**U. S. NUCLEAR REGULATORY COMMISSION
TECHNICAL EVALUATION REPORT FOR
THE U.S. DEPARTMENT OF ENERGY IDAHO
NATIONAL LABORATORY SITE
DRAFT SECTION 3116 WASTE DETERMINATION FOR
IDAHO NUCLEAR TECHNOLOGY AND ENGINEERING
CENTER TANK FARM FACILITY**

October 2006

Figure 10. CPM/Gallon Versus Cumulative Gallons Pumped for Tank WM-182 (From Figure 13, DOE Idaho, 2005)

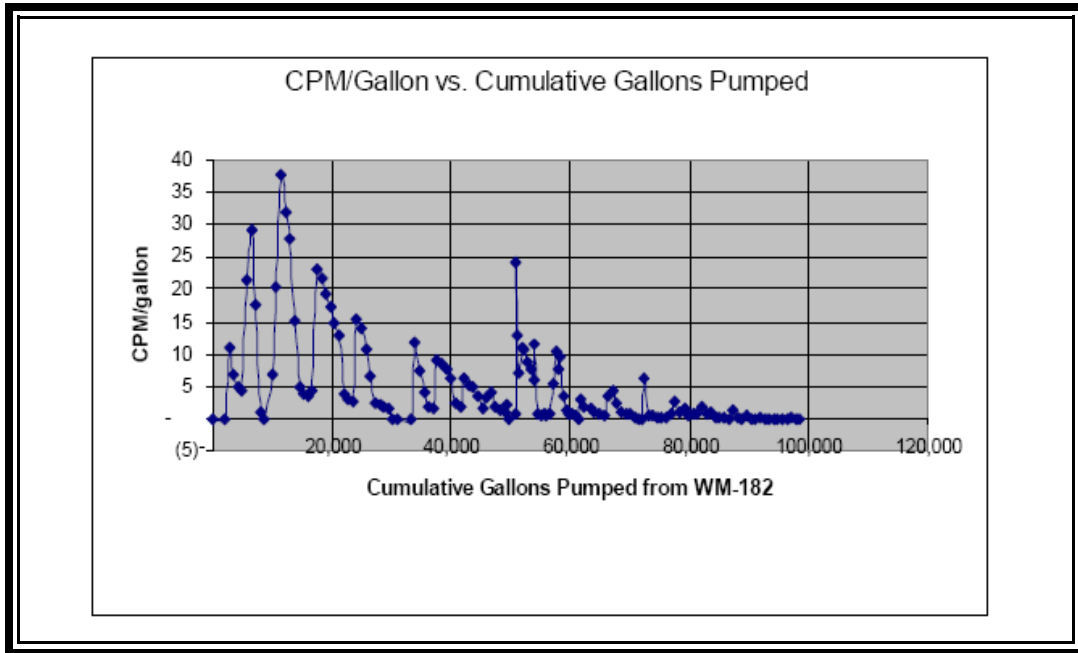
which would indicate that further flushing of the tank internals provided no further waste removal (see Figure 10); and (ii) comprehensive remote visual examinations of the tank internals after each day's cleaning showed that the spray washing was no longer removing further waste residuals (DOE Idaho, 2006a). While use of a radiation detector is expected to be a valuable tool, the efficiency of the instrument is unknown and is expected to be low (the GM detector is located on the outside of the piping and thus, would only be able to detect high energy gamma emitters). Consequently, the use of visual tools to ensure that all areas where significant solid residuals remain are targeted for cleaning is an important part of the demonstration that HRRs have been or will be removed to the maximum extent practical at INL. Additionally, optimization of the operational parameters for the cleaning system provides additional confidence that HRRs have been removed to the maximum extent practical.

Figure 11. Kriging Analysis to Determine Residual Solid Waste Volume (From Figure 1, Portage 2005a)

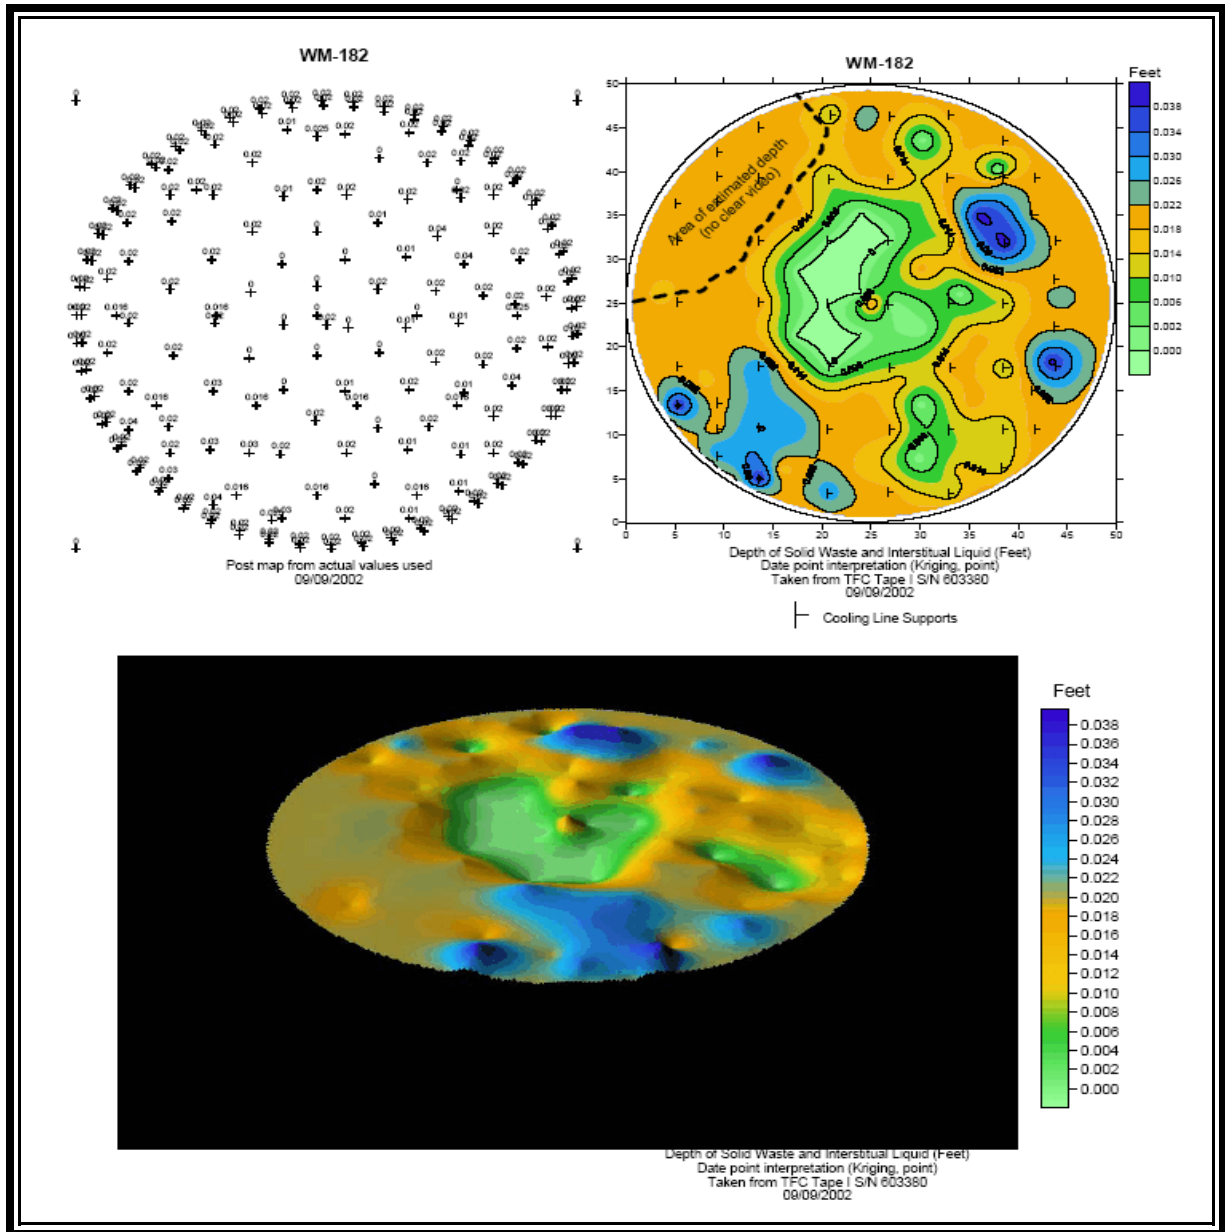
In its response to NRC RAI 5, DOE Idaho provided additional information regarding the number and distribution of control points used in the kriging analysis for tanks with cooling coils and those without cooling coils (DOE Idaho, 2006a). For tanks where cooling coils could not be used for estimating residual waste thickness, DOE Idaho states that 1-in-diameter piping sections were cut into 1-in lengths, placed in the tanks, and used with the bottom tank welds to estimate solid residual depths. The approach used to map out reflective areas of the tank where no residual solids appear to exist is reasonable and prevents gross under or overestimation of residual solid volumes (see Figure 13). The apparent tendency to overstate the depth of contamination where reference points do exist in the tank appears reasonable to compensate for any potential underestimation associated with an inadequate number or distribution of interpolation points between control points in the kriging analysis. Because the density of the residual solids is fairly uncertain [i.e., dry solid samples have a density around 2 g/cm³ (DOE Idaho, 2006a)], the use of a density of 1.4 g/cm³ is considered realistically conservative, because DOE Idaho did not attempt to take credit for a reduction in the inventory due to the presence of interstitial liquids in the solid residual heels.

Figure 12a. Plan View of Tank, Vault, and Sand Pad (From DOE Idaho, 2006a)

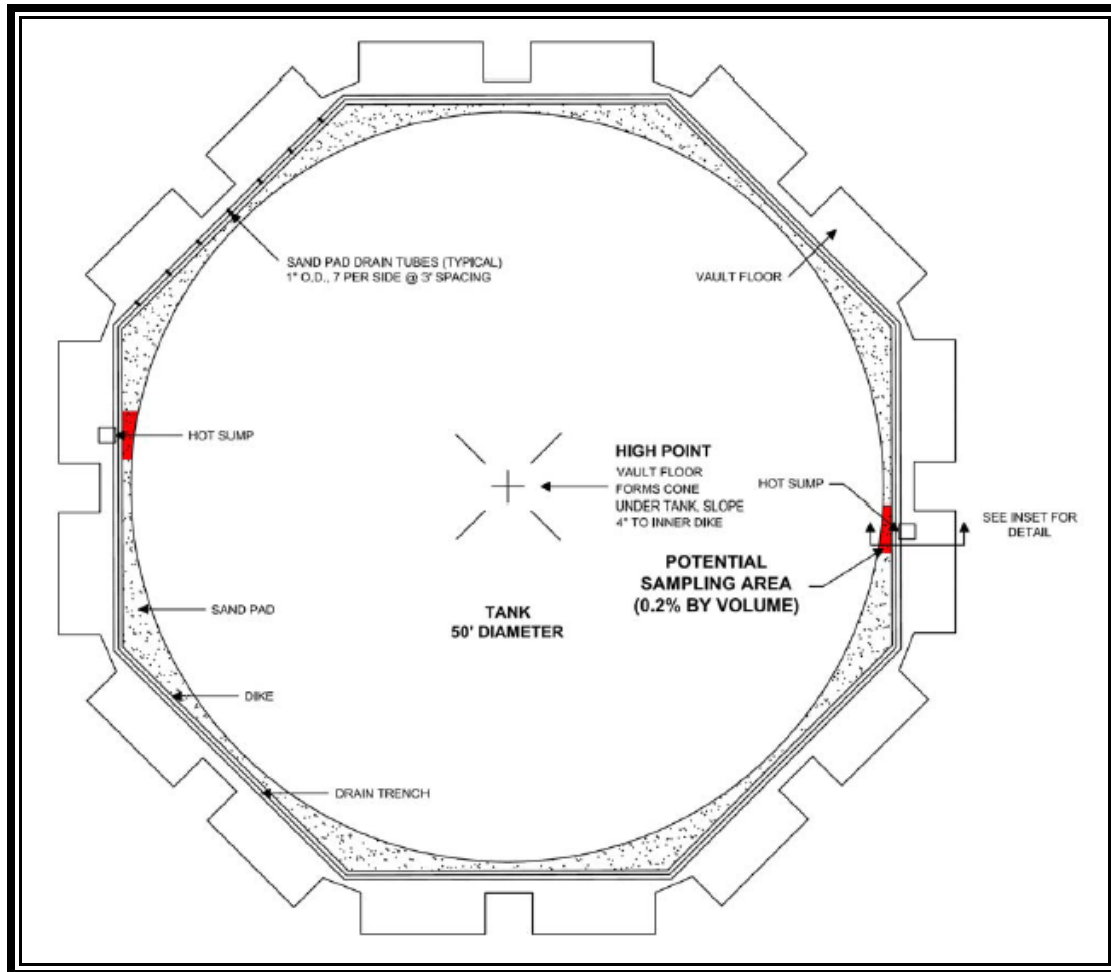
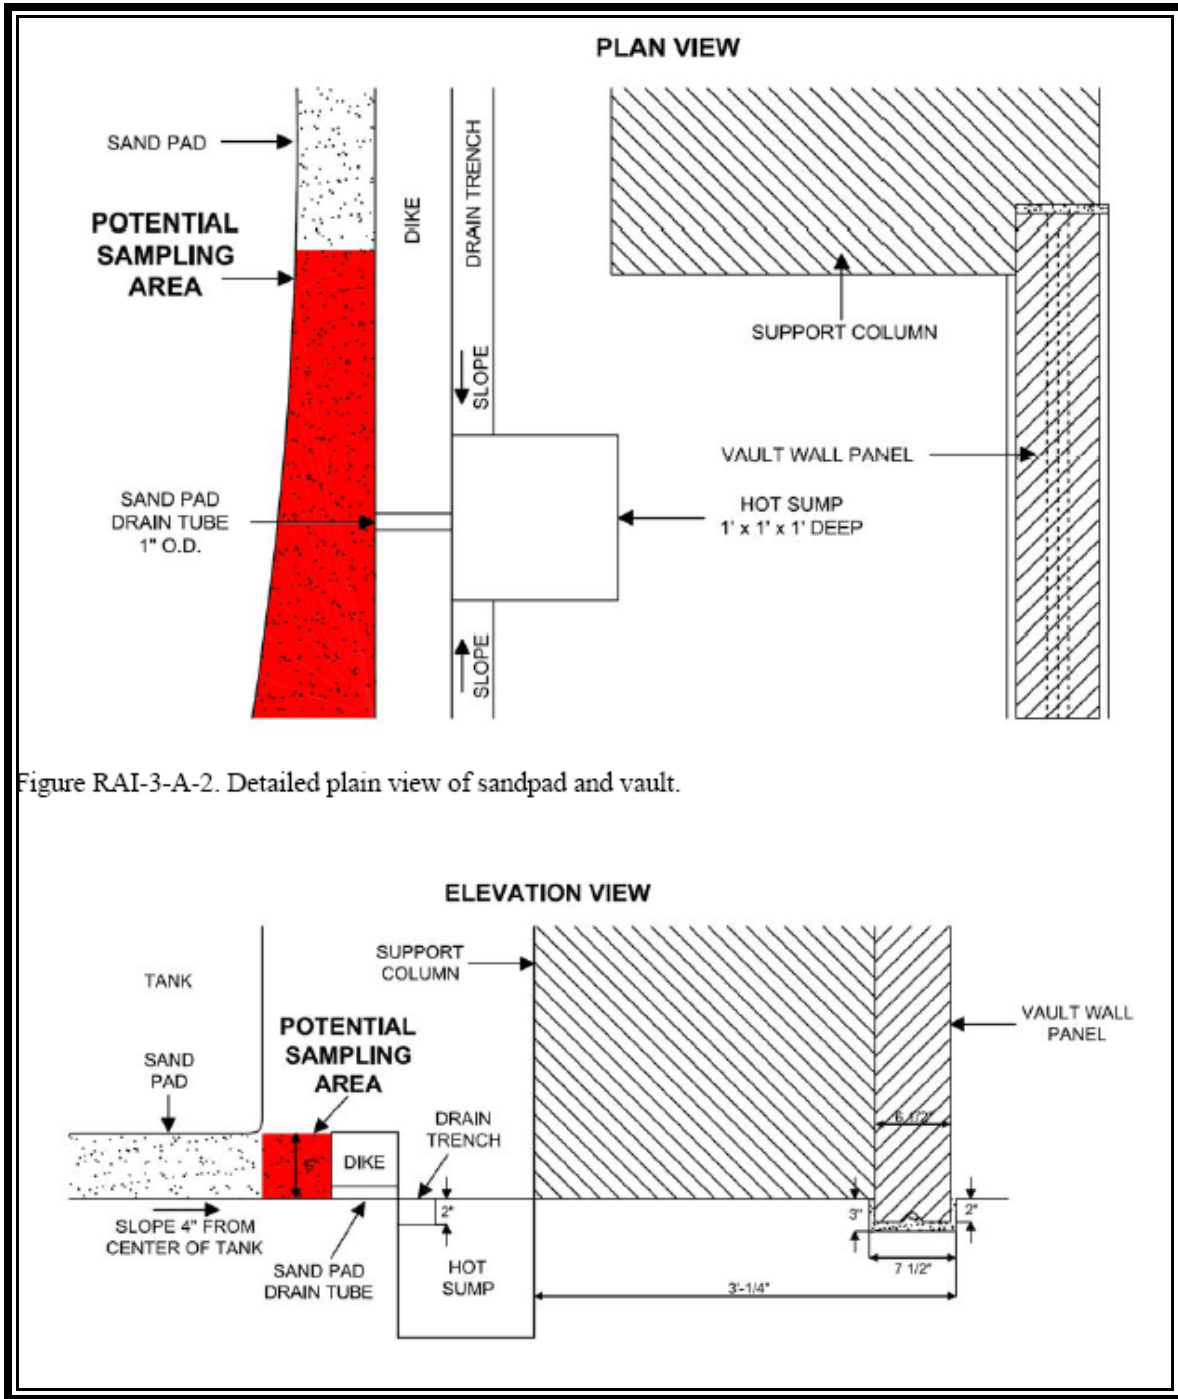
The NRC staff was also concerned about the lack of direct sampling of the sand pad and the fairly uncertain modeling approach and parameters used to estimate the sand pad inventory (RAIs 1, 3, and 4; NRC, 2006a). Based on information provided in the contamination event report (Latchum, et al., 1962), NRC staff questioned (NRC, 2006a) the conceptual modeling approach (e.g. one-dimensional, diffusion model) used in the PA (DOE Idaho, 2003a). In

DOE Idaho also discussed (DOE Idaho, 2006a) the difficulty in direct sampling of the sand pads in its response to NRC staff's RAI 1. Access to the sand pads is through two 12-inch risers, which presently contain other equipment that almost completely occupies the available space. The access risers might allow collection of sand from the edge of the sand pads near the sump. Figure RAI 1-B-1 (DOE Idaho, 2006a) shows a plan view of the tank and sand pads (see Figures 12a and 12b). DOE Idaho explained that only extreme measures would allow sand pad samples to be collected and that the samples would be highly variable and uncertain, making it difficult to use the sampling data to predict the inventory in the sand pad. NRC staff appreciates the difficulty in sampling the sand pad and concludes DOE Idaho made a good faith effort to evaluate the uncertainty in the sand pad inventory through additional sensitivity and uncertainty analysis, modeling, and analysis of indirect sampling data. The sand pad inventory is adequate for the purpose of assessing DOE Idaho's demonstration of compliance with NDAA Criteria 2 and 3.

In response to RAI 1, DOE (DOE Idaho, 2006a) addressed the issue regarding the lack of direct sampling of the sand pad by analyzing radionuclide concentrations of liquids sampled after vault cleaning. Liquids in the sand pad drain through drain tubes to the vault sumps. Therefore, liquid vault sump concentrations can provide an indirect method of “sampling” the liquid concentrations in the sand pad. Vaults with contaminated sand pads did not show elevated concentrations of radionuclides compared to vaults without sand pad contamination. DOE Idaho concluded that the detection of lower concentrations of most radionuclides indicates contamination in the sand pads is considerably lower than the estimated 3,850 Ci (DOE Idaho, 2006a).

With respect to the sand pad inventory modeling, DOE Idaho stated in response to NRC staff's clarifying RAI 20 that over 100 "flushing events" have occurred, but only 38 events removing contamination from the sand pad were assumed. Thus, with respect to the sand pad modeling, a factor of two lower concentrations of Sr-90 would have been estimated had DOE Idaho taken credit for 100 pumping events. On balance, DOE Idaho's modeling approach attempts to bound the inventory of HRRs in the sand pad.

Figure 13. Surface Contour Map for WM-185 Showing Residual Contamination on Edge of Tank (From Figure 1, Portage, 2005b)

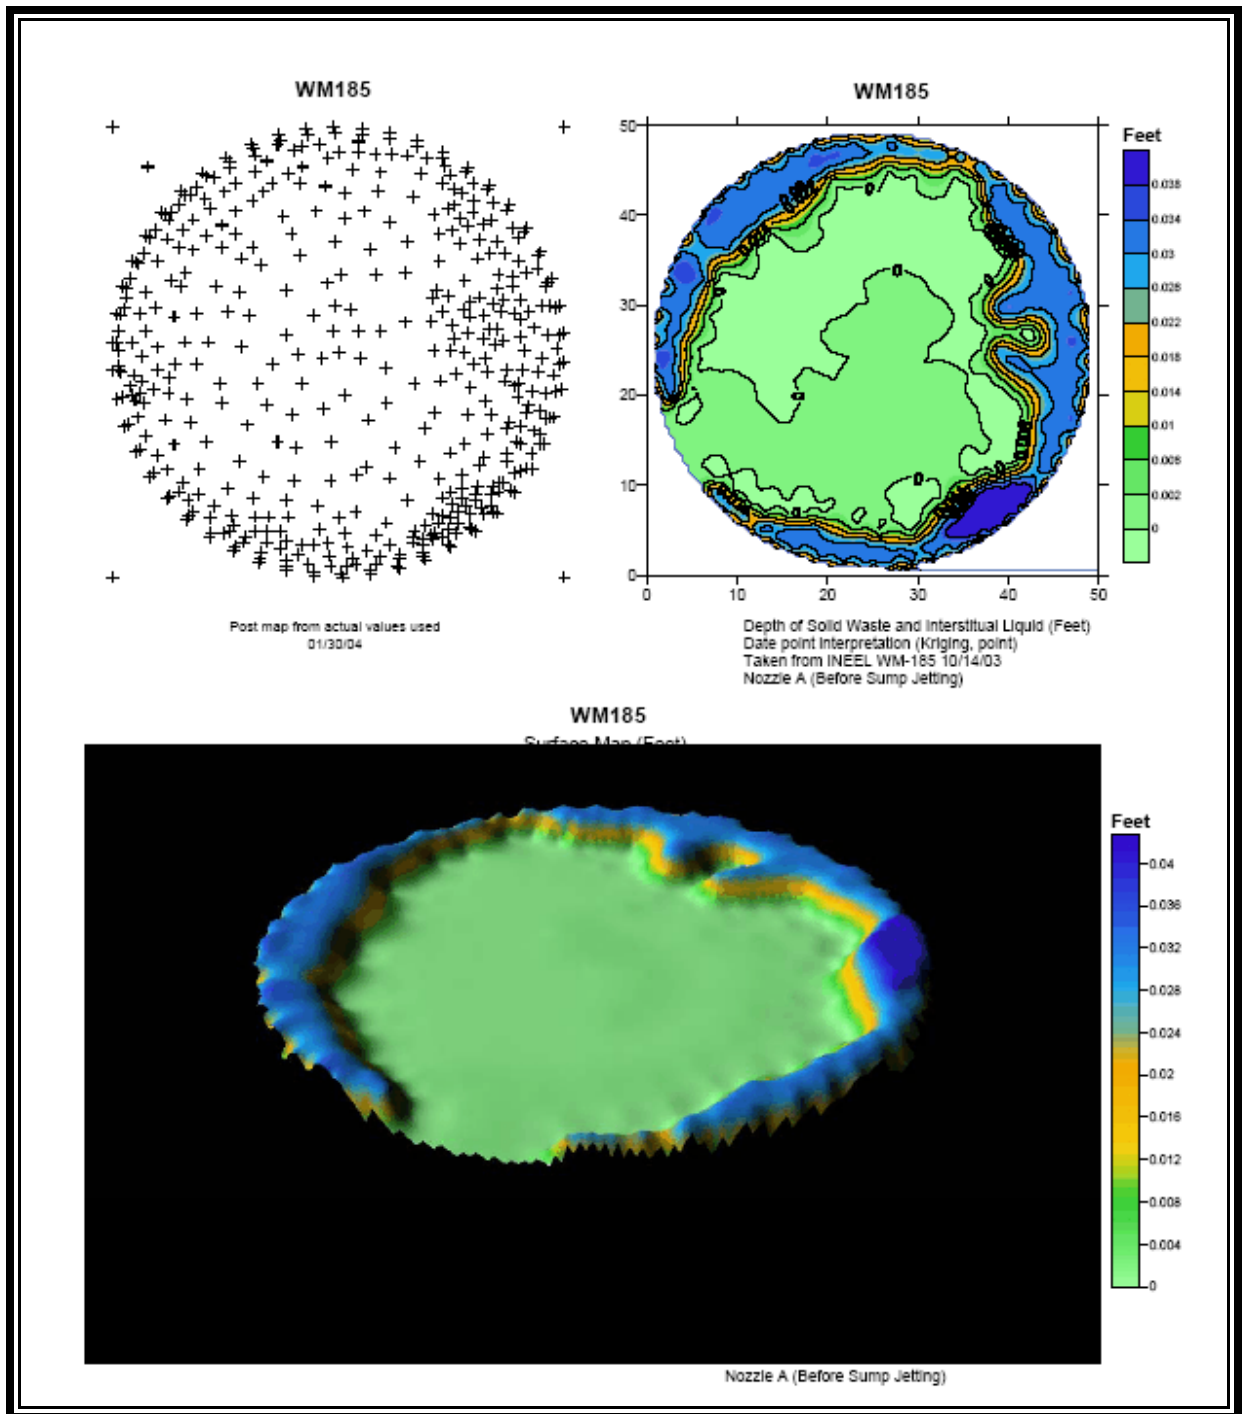
In response to NRC's RAI 2, DOE Idaho explained that no meaningful statistical evaluation could be performed to prepare a DQA for the solid sampling (DOE Idaho, 2006a). The Draft Section 3116 Determination did not discuss the very significant differences between expected versus actual inventory for specific radionuclides presented in Appendix A of the document (DOE Idaho, 2005). However, DOE Idaho presented a number of additional solid sample results from various pre- and post-cleaning sampling events in tabular format for easy comparison (DOE Idaho, 2006a). Based on a review of this limited information, it appears that there is significant variability (an order of magnitude or higher) in the solid concentrations from tank to tank (e.g., Sr-90 and Cs-137). There is also significant variability in concentration from pre- and post-cleaning sampling for certain radionuclides (e.g., Sr-90 concentrations vary over an order of magnitude). The variability in concentrations of HRRs between tanks is important when estimating the expected removal efficiency of HRRs for tanks that have not been cleaned, because uncleaned tank WM-188 appears to have a significantly higher concentration of the relatively insoluble constituent Cs-137 that is present in cleaned tanks.

Additionally, tank WM-187 is the holding tank for waste removed from tanks WM-180 through WM-186, so there may be additional challenges with cleaning tank WM-187 due to the accumulation of solids from multiple tanks. DOE Idaho should attempt to sample tanks WM-187 through WM-190 (particularly tanks WM-187 and WM-188) following cleaning operations to ensure that the inventory for these tanks is not significantly underestimated.

Figure 15. Representation of Thickness of Grout Needed to Meet Class C Concentration Limits (from DOE Idaho, 2005)¹³

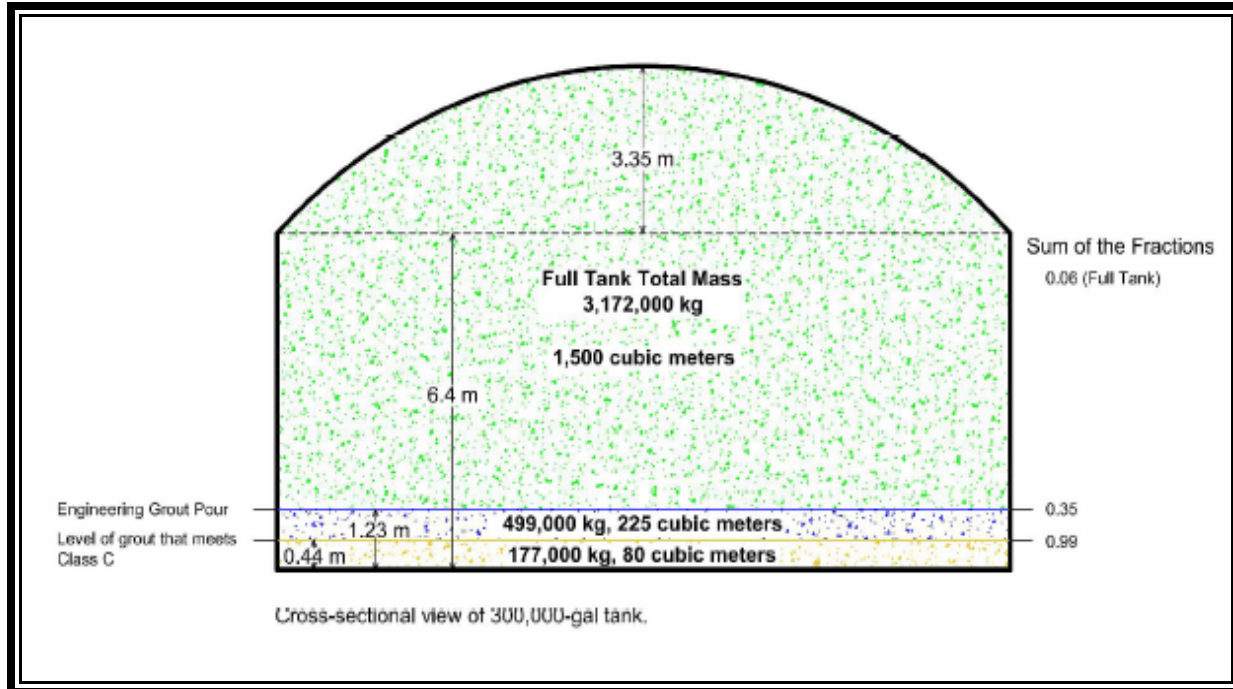
In the case of the large tanks at INL, DOE Idaho did not exhaust all acceptable methods provided in the draft guidance for averaging the waste inventory over a larger volume of grout (10 times the mass or volume of the waste) in its calculation of the sum of fractions which resulted in a value of 14 for all tanks. Most significantly, DOE Idaho did not take credit for the volume or mass of liquid residuals which contributes most of the residual waste volume (about 80 percent) in calculating an acceptable volume of stabilizing grout. Consideration of the liquid residual waste volume increases the allowable amount of stabilizing grout by up to a factor of five if ten times the volume of residual waste is used.¹² DOE Idaho could also have taken credit

for a portion of the large stainless steel tank walls and floor. When these credits are included, NRC staff calculations show a sum of fractions of 0.6 for Tank WM-181, the tank with the lowest inventory, and a sum of fractions of 2.8 for Tank WM-182, the tank with the highest inventory (see Table 7, column 4). If stabilizing grout in the amount of ten times the volume of waste is assumed in the waste classification calculations for all radionuclides, including transuranics that have Class C concentration units expressed in activity per unit mass (see Table 7, column 2), the range of sum of fractions is even lower, from 0.3 to 1.5 (see Table 7, column 5).

Figure 18. Cross Section of Tc-99 Plume (From DOE Idaho, 2006c)

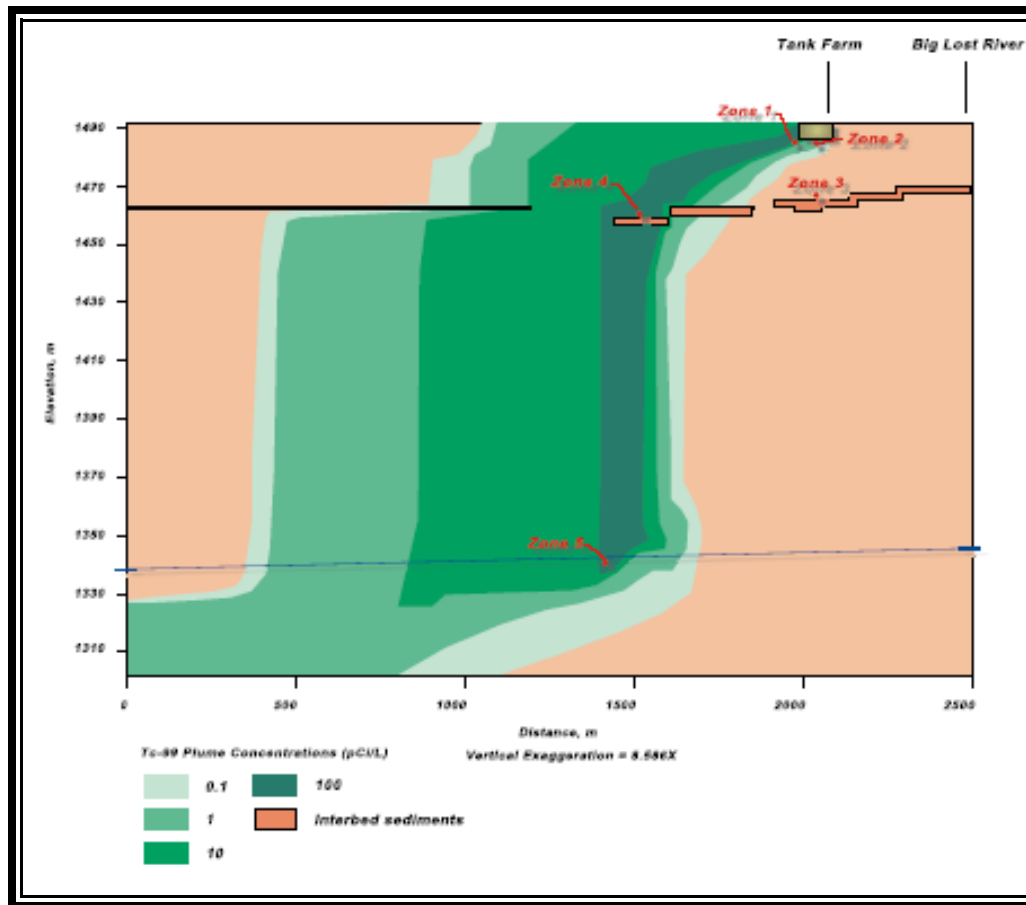
¹⁵ It is important to note that the figure DOE Idaho provided to NRC to correct the locations of sedimentary interbeds resulted in inconsistent display of the center-line of the Tc-99 plume (see Figure 18) that shows a center-line of 100 pCi/L in DOE Idaho (2006c), compared to Figure 4-2 in DOE Idaho (2003a) that shows a center-line of

Locations where interbeds are thin to absent greatly affect the downward migration of radionuclides. Consequently, DOE Idaho concluded that the hydrostratigraphy defined by the Anderson, et al. (1991) and representation methods implemented in the model (DOE Idaho, 2003a) both played a major role in the modeled migration pattern. DOE Idaho concluded that the 100-m [330-ft] downgradient compliance point was an inappropriate location at which to quantify the groundwater pathway dose to a member of the public because the maximum modeled concentrations occur approximately 600 m [2,000 ft] downgradient from the tanks. Thus, this point of maximum concentration in groundwater was chosen for the compliance point, and it is at this location that nodal contaminant concentrations were averaged for the upper 10 m [33 ft] of the aquifer to estimate the concentrations expected in a water well screen of this length.
